## DRAFT DELEGATED OFFICER REPORT

| <b>PROPOSAL</b>                  | <b>Erection of 90 dwellings with associated landscaping, parking and improved access.</b> |
| <b>LOCATION:</b>                 | Proposed Development site (former Electricity Board site), Bartons Road, Havant           |
| <b>REFERENCE NO:</b>             | APP/25/00639                                                                              |

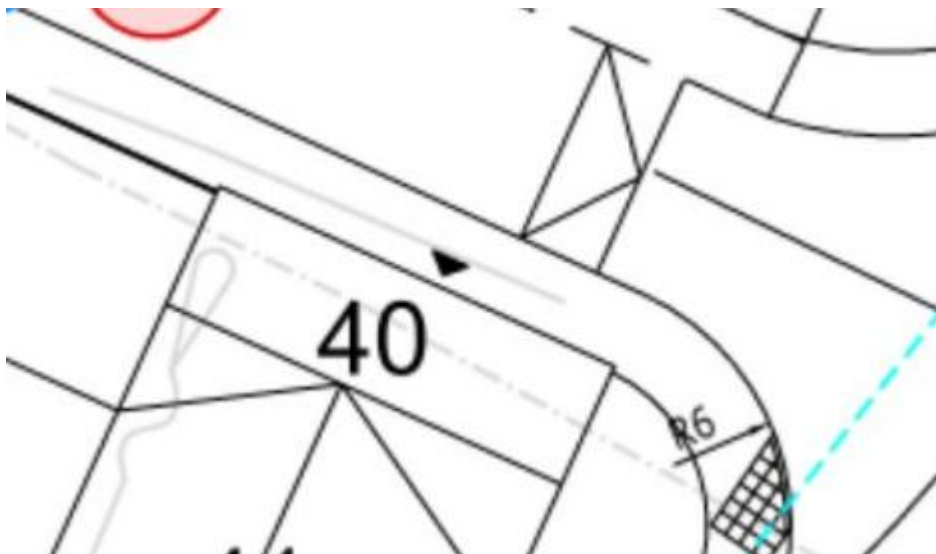
Upon review of the internal site layout plan, whilst a shared use path has been provided along the main spine road, a visitor space on the opposite side of the road to plot 8, slightly overhangs (top left of the space) the shared use path, which is not acceptable. Furthermore, there are several other visitor bays that are missing a hardstanding area for accessing the vehicle, and therefore a hardstanding to the rear of the visitor spaces should be provided. Additional crossing points where appropriate should also be provided in the vicinity of the visitor bays to allow pedestrians to safely cross.

The location of the parking space for plot no.1 on the spine road should be provided and confirmed, as in accordance with HCC TG2 guidance driveways shall not be within 10m of a proposed priority junction.

There are concerns throughout the site regarding dwelling plots having frontages directly onto roads. Any elevation features like porches or canopies are not acceptable to over sail the highway and this detail must be considered to prevent issues with building control compliance. It is therefore recommended that the frontages of plots are updated to provide a suitable landing depth and footways.
